IEEE 802.11
Wireless Access Method and Physical Layer Specification

Title: Proposed Revision of the Infrared Baseband Frame Format

A new frame format for the IR baseband is proposed. Its performance and implementation complexity is compared to the frame format proposed in documents 94/95 and 94/96. The terminology used to describe the frame format is also revised.

Figure 2. FER vs. irradiance

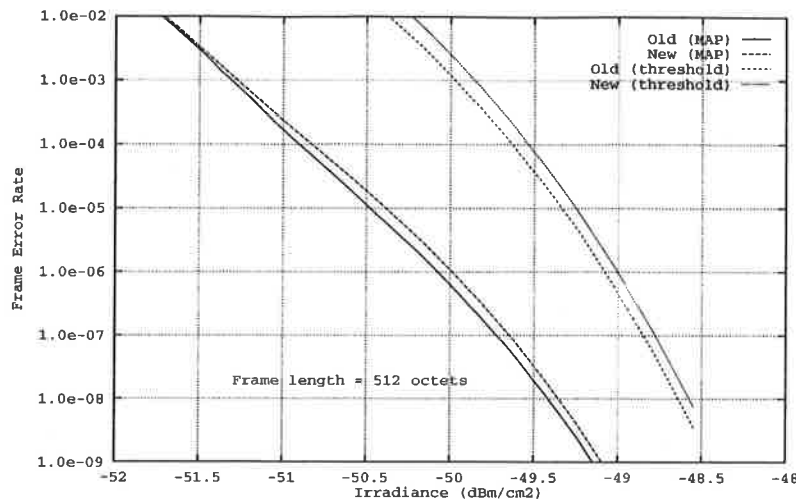
Figure 2 shows the FER versus irradiance for the proposed frame format when a MAP detector and a threshold detector are used. These results are also compared with those of the old frame format.

As shown in figure 2, there is a small penalty associated with the new frame format (about 0.1 dB) and this results from the error probability associated with the LENGTH and CRC fields detection.
